Subject: AP1000 Response to Request for Additional Information (TR 85)

# AP1000 TECHNICAL REPORT REVIEW

RAI Response Number: RAI-TR85-SEB1-32  
Revision: 2

**Figure RAI-TR85-SEB1-32-1**  
Comparison of Vertical Stress at Basemat Bottom Node – No embedment

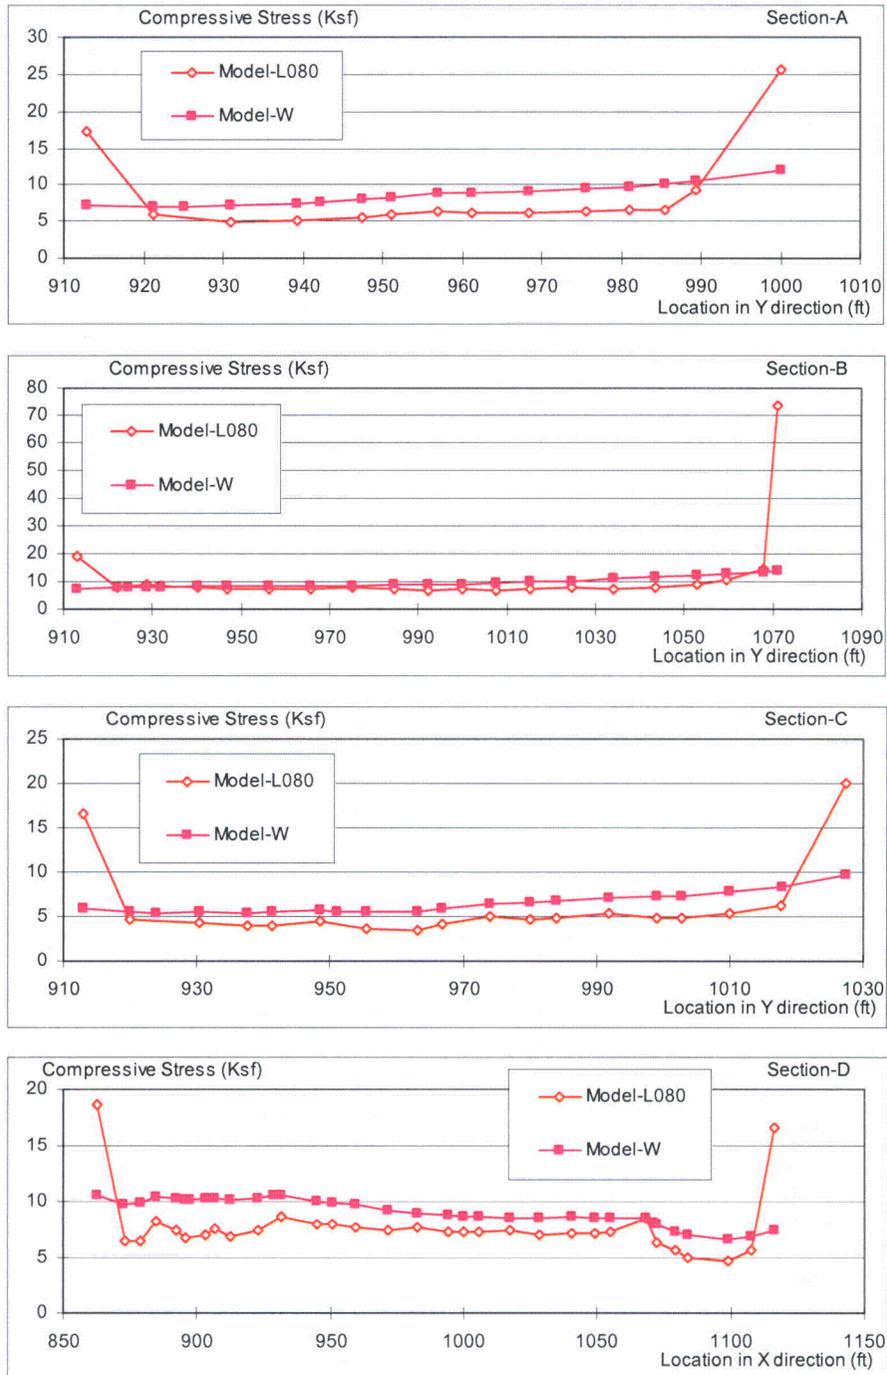
2. As noted in the original RAI, the studies in Section 2.7.1.2.1 demonstrate that when the soil is represented as solid elements, higher bearing pressures occur at the edges than when uniform Winkler type soil springs are used. This is a well known behavior in soil mechanics and is referred to as the Boussinesq effect. Since the current dynamic soil bearing pressure demand criterion of 35 ksf is still based on the 2D ANSYS stick model analysis, Westinghouse is requested to either (1) justify the statement that the localized peak soil pressures will redistribute if local stresses in the soil are excessive and the NI will still be stable or (2) explain what is the technical basis for using a uniform soil spring representation rather than soil brick

Figure RAI-TR85-SEB1-32-1 shows bearing pressures due to dead load. The sections are located as shown in Figure 2.7-2 of the technical report. The RAI figure only shows the two cases identified above. The finite element soil model shows high local bearing pressures close to the edge. This is due to the Boussinesq effect. The higher pressures at the edge result in lower pressures away from the edge. Figures RAI-TR85-SEB1-32-2 and 3 show bending moment contours MX and MY for these two cases. It is seen that the bending moments for the soil spring case are higher than those for the soil finite element model even in the bays immediately adjacent to the edge.

Figure RAI-TR85-SEB1-32-7  
Boussinesq Influence Values for Footing Contact Pressure  
(rigid circular footing at ground surface, for half space)

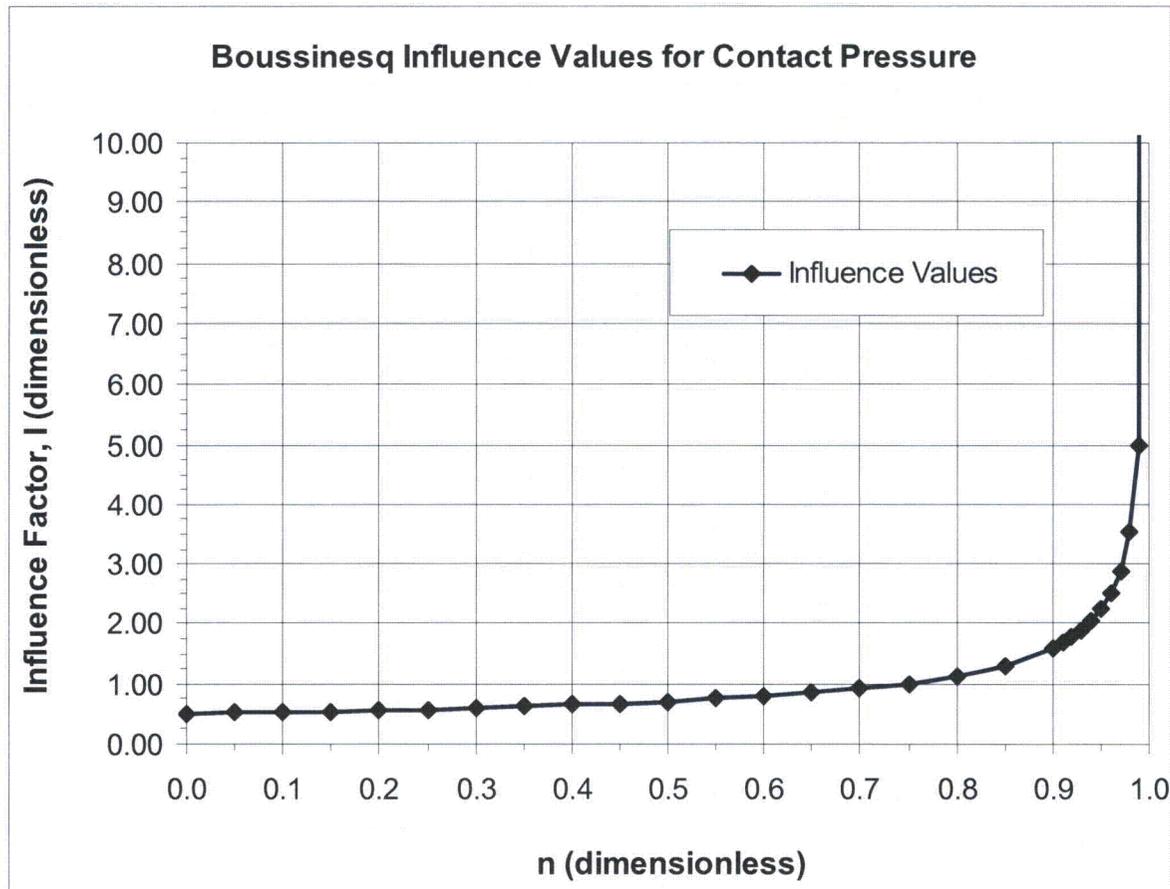
The RAI response indicates that the seismic analysis for determining the soil bearing pressure demand has been revised to utilize the SASSI 3D finite element NI20 model using a seismic time history soil-structure interaction analysis. This analysis was performed for the hard rock case and five soil conditions. The model includes a surrounding layer of excavated soil and the existing soil media. The soil media in SASSI is an idealization of the various horizontal soil layers. This representation of the soil in SASSI is considered to be more realistic and accurate than the uniform Winkler type soil springs used in the 2D ANSYS analyses, and thus addresses the concern regarding the calculation of soil bearing pressure demand. However, for the design of the basemat, Westinghouse has not demonstrated that its use of uniform Winkler type soil springs is adequate. As noted in the prior RAI, due to the Boussinesq effect in soil, the distribution of stiffness would be higher at the edges and lower away from the edges. Therefore, Westinghouse is requested to demonstrate that the use of the uniform soil springs for the design of the foundation is acceptable, when it is known that the actual distribution of the soil stiffness would not be uniform.

The studies documented in section 2.7 of the technical report and summarized above show the Boussinesq effect in rock and soil with an effective stiffness that is higher at the edges and lower away from the edges. This distribution is presented on Figure RAI-TR85-SEB1-32-7. The influence values represent the effect of the contact on a half space beneath a rigid circular footing. The Boussinesq equation does not account for the influence of the basemat's embedment depth of 39.5 feet which would increase the bearing capacity of the foundation. Because of the basemat dimensions (plan and thickness), the foundation would be considered flexible. The studies demonstrate that the use of uniform Winkler type soil springs is adequate for a flexible mat foundation.
